## **Addendum No. 1**

**Date:** July 24, 2024

**Project:** Hillsborough County Sheriff's Office Regional Canine Training Facility

**Architect's Project Number:** 23164.01

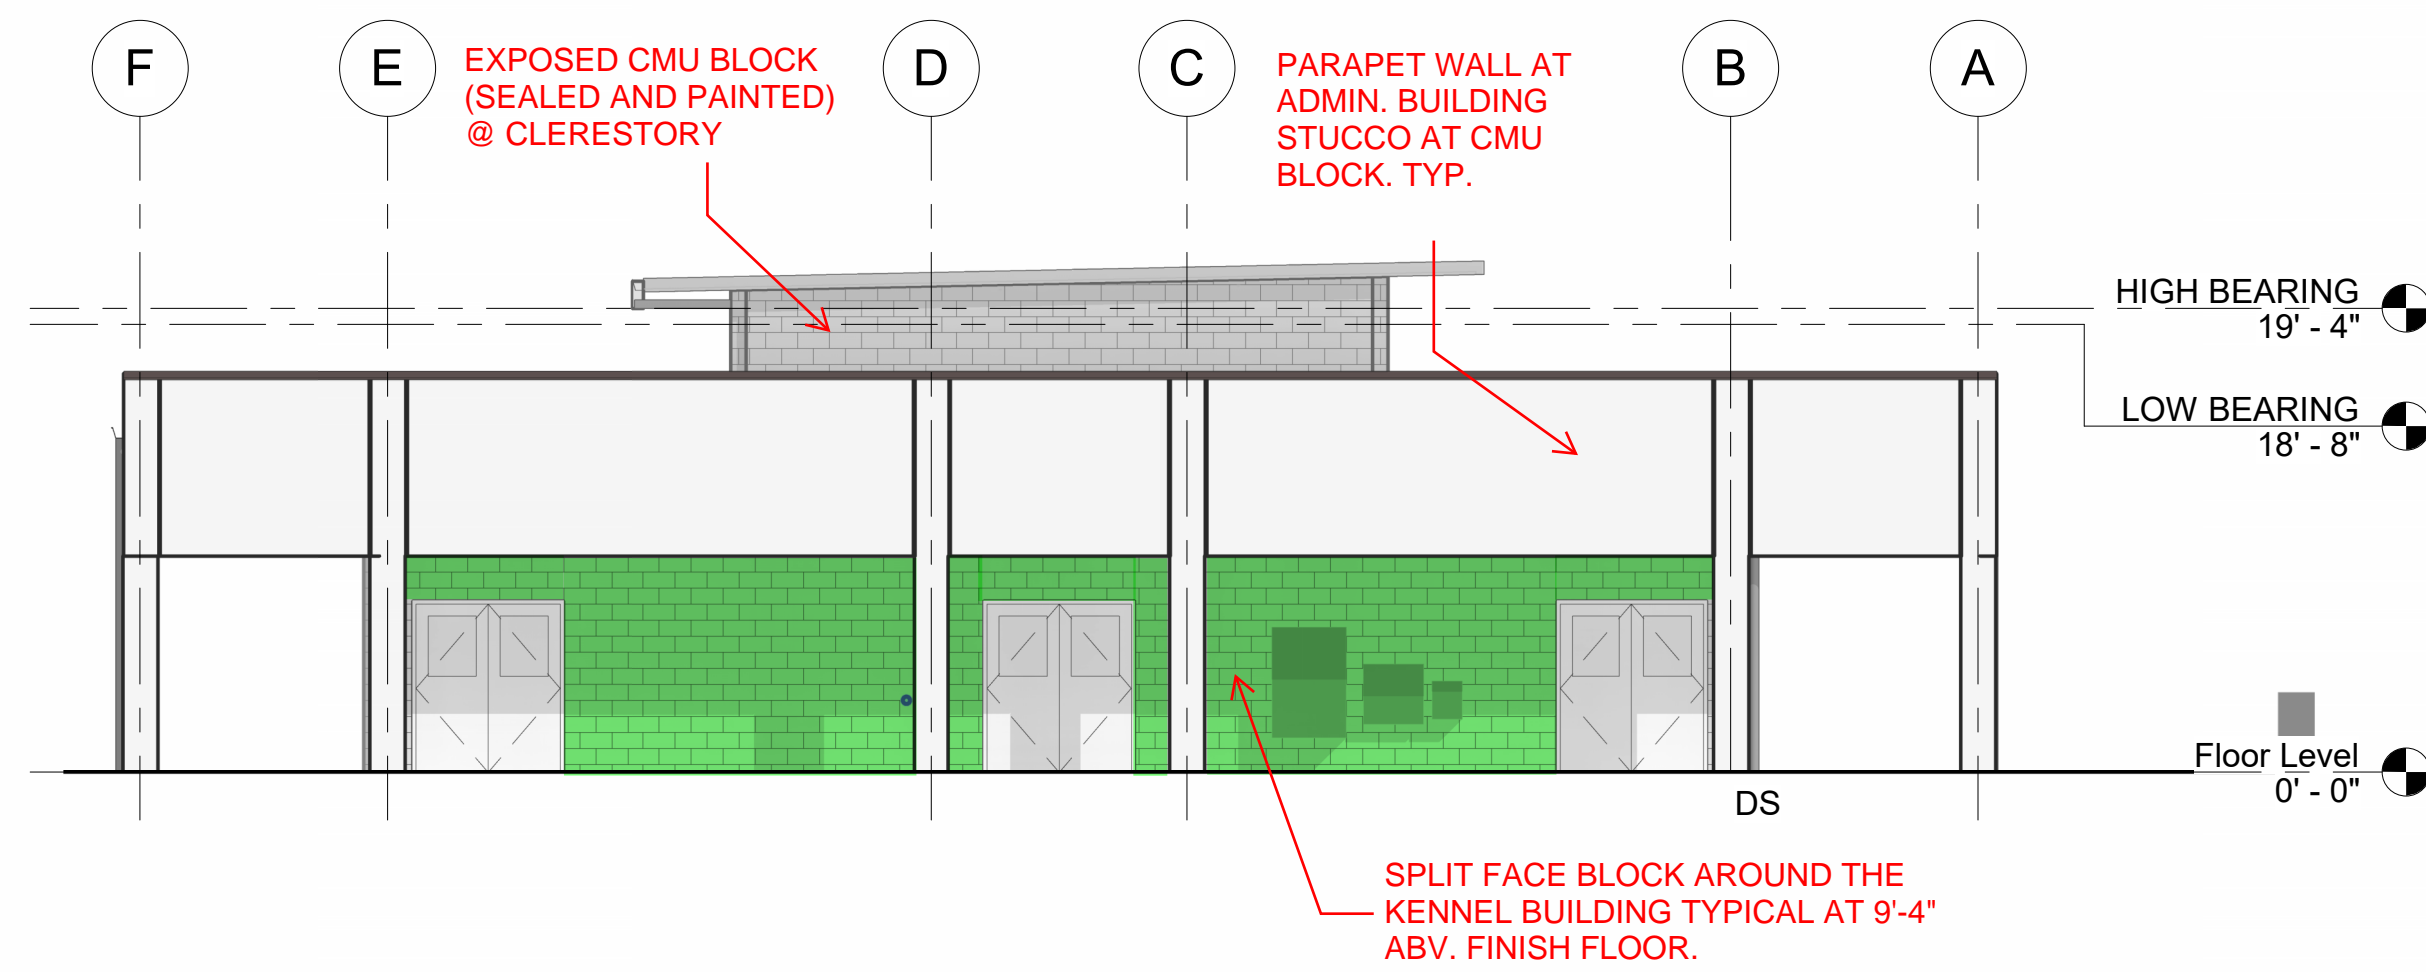
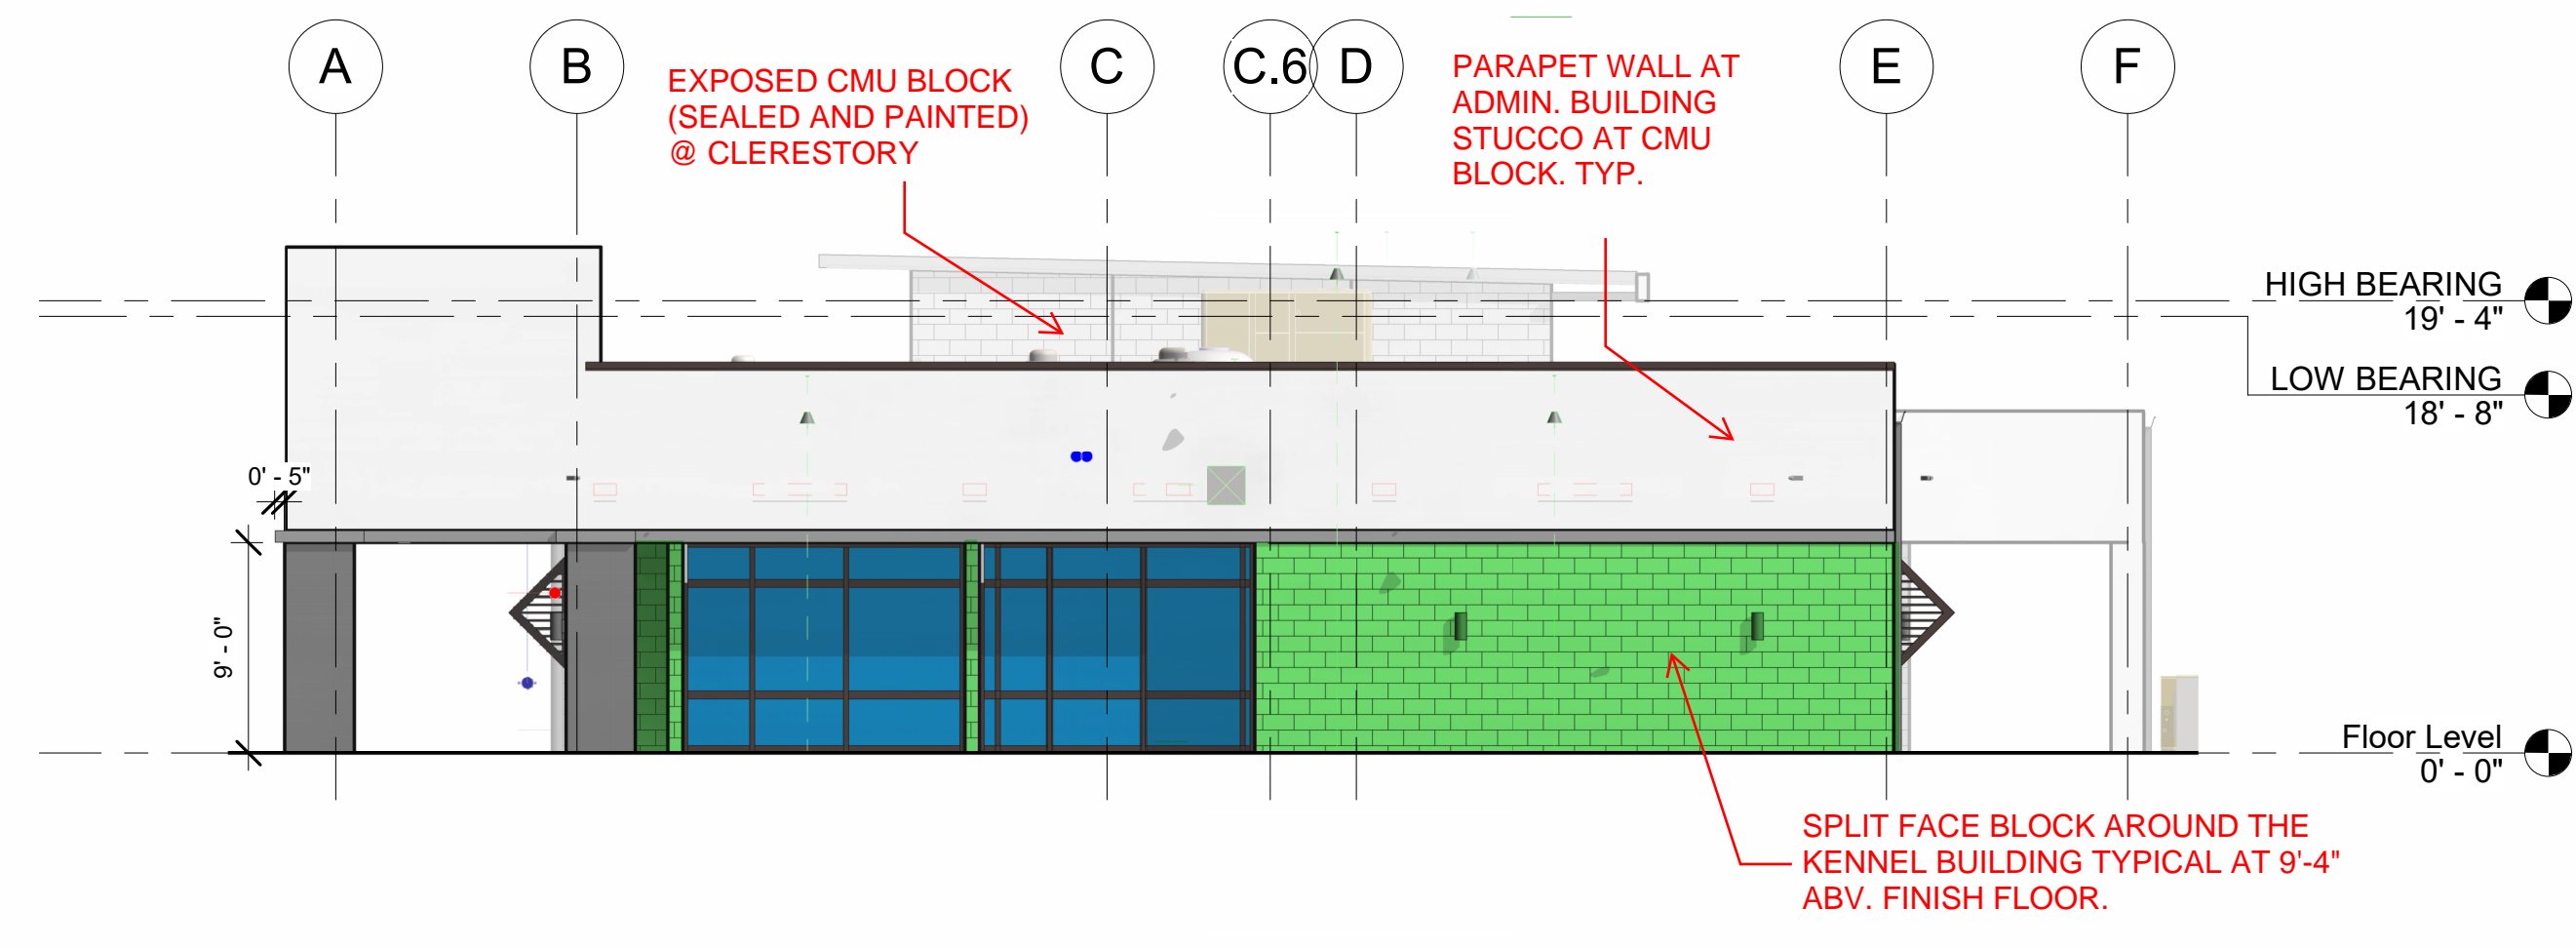
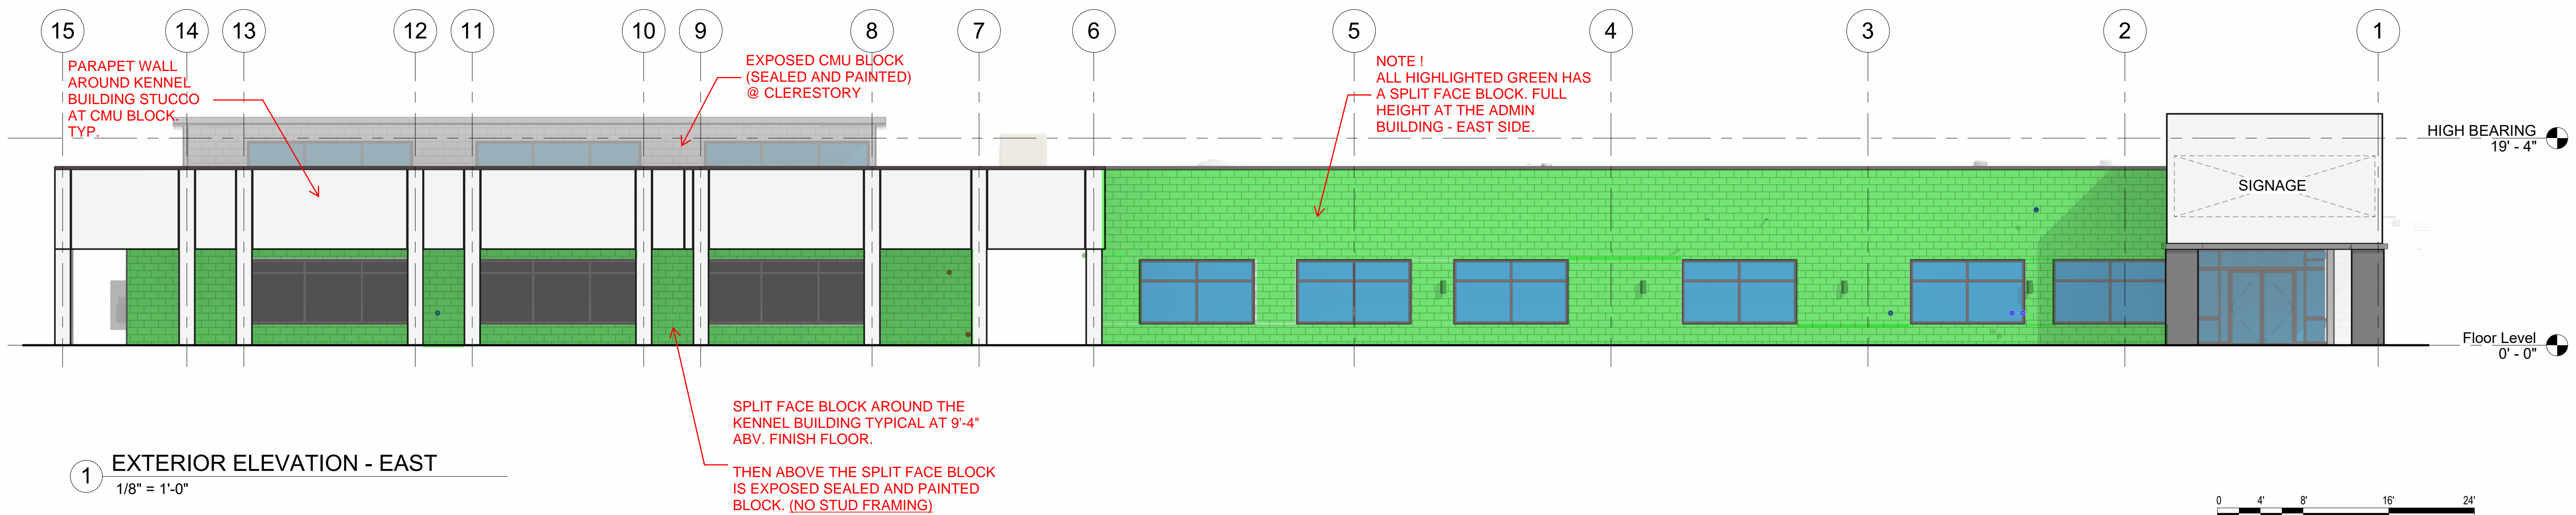
35		Please identify the location of the split face block vs regular blocks?	Refer to attached building elevations. Split-face block locations are indicated with a green hatch.
36	C-4.2B note 14	Please provide details for dumpster enclosure ( blocks type, foundation) on page C-4.2B note 14	Dumpster enclosure to be of split-face block to 7'-4" above finish grade with double 6'-0" high galvanized swing gates with privacy slats. Drawings to be provided at a later date.
37		Please provide specs for the precast architectural concrete 34.500 in the specs.	Not applicable. See reponse to item no. 12 above.
38		Please confirm the countertop material in room 201 and room 108 (Bite-suit & Food Storage and Copy Room).	Provide solid surfacing counter tops. See item no. 73 below. Updated documents to soon follow.
39	P-601, P-401 and P-201	Plan page P-601 shows the water closet to be flush valve type. These require a 1" water line. Plan pages P-401 and P-201 show pipe sizing to all the water closets to be 1/2". Please clarify. If flush valve water closets are to be used, please provide new drawings showing the increase in all pipe	The stone face veneer has not been specified - provide an appropriate allowance. Veneer shall be mortar applied with appropriate brick ties and installed per manufacturer's recommendations.
